2 Type of change

- Nickel plated case instead of aluminium case
- Production transfer from Slovakia (SK) to Romania (RO)

Product Change Notification					PCN FMW-52 and FMAB case 09 redesign		
owner	creation date	release date	released by	change order no	rev	page	D10-032-874
segatro	04.01.2019	16.01.2019	romanogu	2016836	A	1 of 2

Old mechanical drawing	New mechanical drawing
<p>Case 09 with quick connect terminals class I</p>	<p>Case 09 with quick connect terminals class I</p>
<p>Case 09 with quick connect terminals class II</p>	<p>Case 09 with quick connect terminals class II</p>

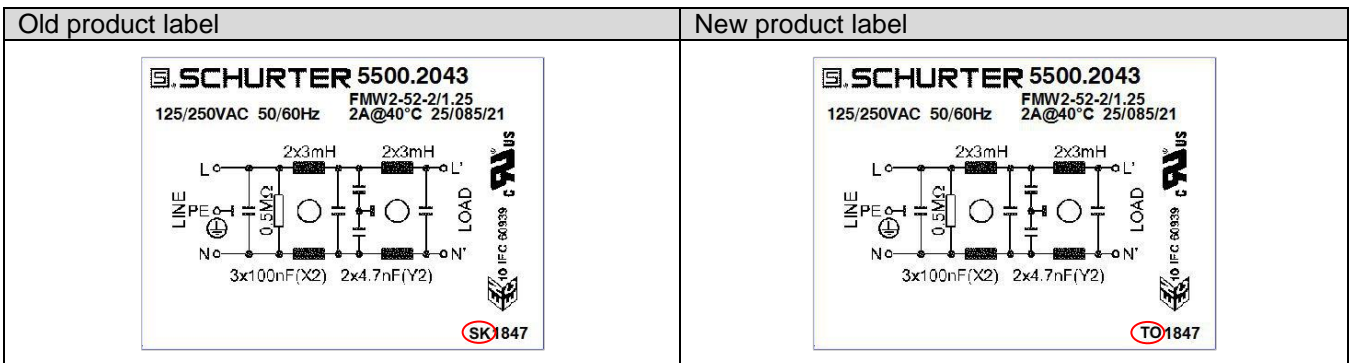
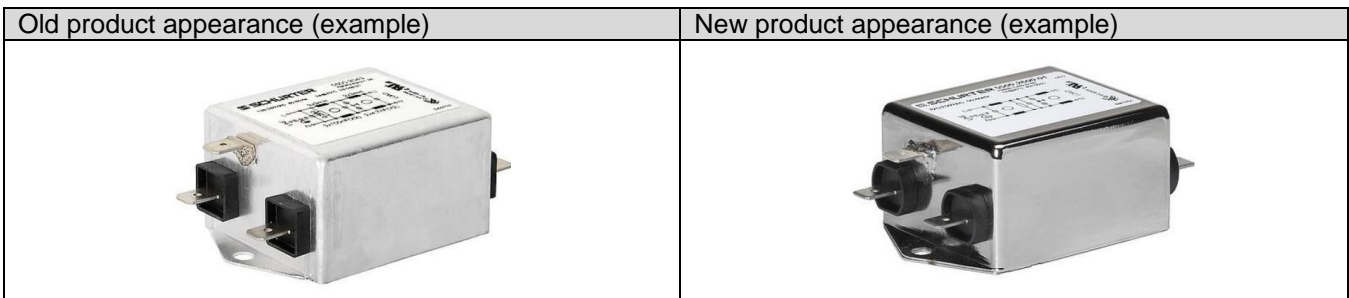
- Change of product appearance due to new nickel plated case instead of aluminium case and different shape of plastic part for quick connect terminals see photo below
- Change of factory code from SK to TO and origin from SK to RO on product and packaging labels, see below
- Different shape of plastic part for external quick connector terminals
- New cases are provided with a bottom cover
- Position of earth terminal
